*Eagle River Mine T1 Replacement
Notification of Conditional Approval of Connection Proposal
CAA ID Number: 2007-EX334*

ASSESSMENT SUMMARY

Wesdome Gold Mines Ltd.

Figure 1: Eagle River Mine (previously known as River Gold Mine)

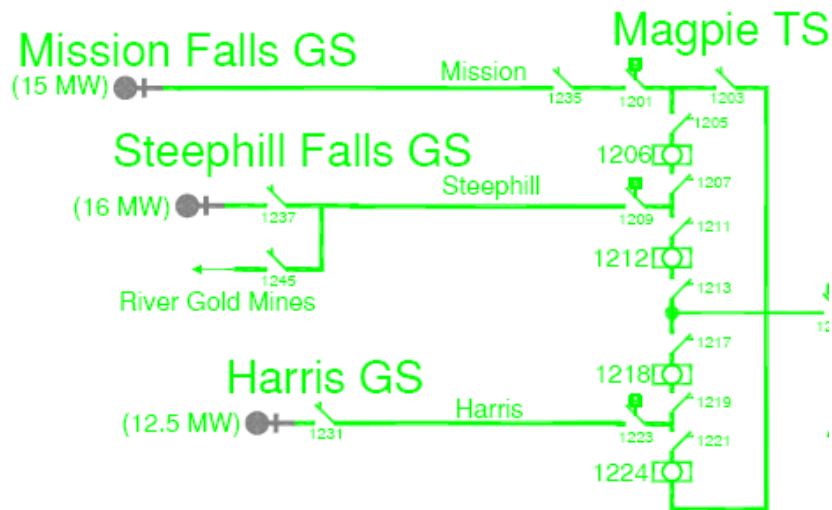
Transformer T1 at Eagle River Mine was replaced due to failure in March 2007. This transformer is connected to the 115 kV Steephill line out of Magpie TS. The facility is currently undergoing a name change from River Gold Mine.
